Calvert Cliffs Nuclear Power Plant SUBJECT: Unit Nos. 1 & 2; Docket Nos. 50-317 & 50-318 Second Ten-Year Inservice Test Program Plan

- **REFERENCES**: (a) Letter to Mr. G. C. Creel (BG&E) from Mr. S. A. McNeil (NRC), dated January 12, 1990, same subject
 - (b) Letter to Document Control Desk (NRC) from Mr. J. A. Tiernan (BG&E), dated October 18, 1988, ASME Section XI Pump and Valve Inservice Test (IST) Program

ASME SECTION XI PUMP AND VALVE INSERVICE TEST (IST) PROGRAM

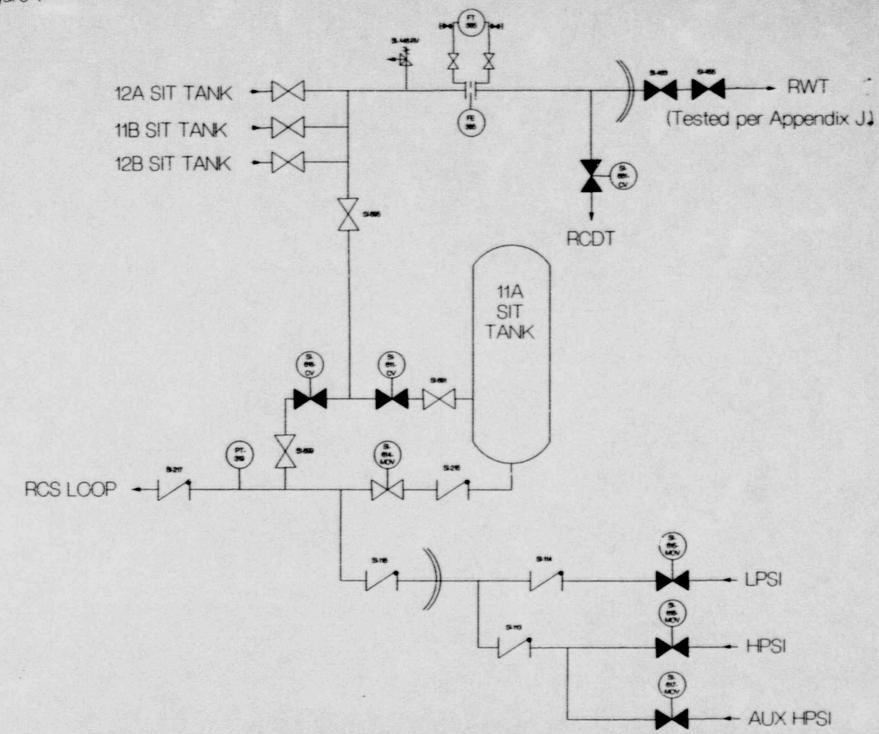
Describe the surveillances, and their associated intervals including grace periods and allowable out-of-service times, for the pressure transmitters 1(2)PT-319 (329, 339, and 349) used to detect leakage past the safety injection pressure isolation valves from the reactor coolant loops 1(2)SI-217 (227, 237, and 247).

Please verify that no leakage paths exist that could mask pressure indications of primary leakage past the safety injection pressure isolation valves 1(2)SI-217 (227, 237, and 247), including any paths on the nigh pressure safety injection side of the containment isolation valves 1(2)SI-118 (128, 138, and 148).

Please refer to Figure 1, page 5, which shows one of the four Safety Injection Tanks, and associated piping.

- a. The leakage path through 1(2)SI-618 (628, 638, and 648) CV's is tested as described in item B.1. earlier. Any leakage past these values will either go into the safety injection tank, which is evaluated every 4 hours for in-leakage, or to the reactor coolant drain tank, which is evaluated for in-leakage daily when gross reactor coolant system leakage is greater than 1 gpm.

- b. The leakage path through 1(2)SI-215 (225, 235, and 245): These values are type AC and tested accordingly in the IST program; additionally any leakage past these values will go to the safety injection tank which is evaluated every 4 hours for in-leakage.

- c. The leakage path through 1(2)SI-118 (128, 138, and 148): These values are type AC values and tested accordingly in the IST Program; any leakage past these values will be contained by the check values 1(2)SI-114 (124, 134, and 144) or 1(2)SI-113 (123, 133, and 143). Although these are not type "A" values they are part of the IST Program and tested for back leakage as the means for verifying value closure in accordance with IWV-3410.

The valves in question, 1(2)SI-217, 227, 237, and 247, are check valves between the reactor coolant system and the safety injection system (see Figure 1). Any back leakage thru these valves will be accounted for and detected as reactor coolant system leakage. Per Technical Specifications, RCS leakage is determined at a minimum every 72 hours with limits of 1 gpm unidentified leakage. Figure 1
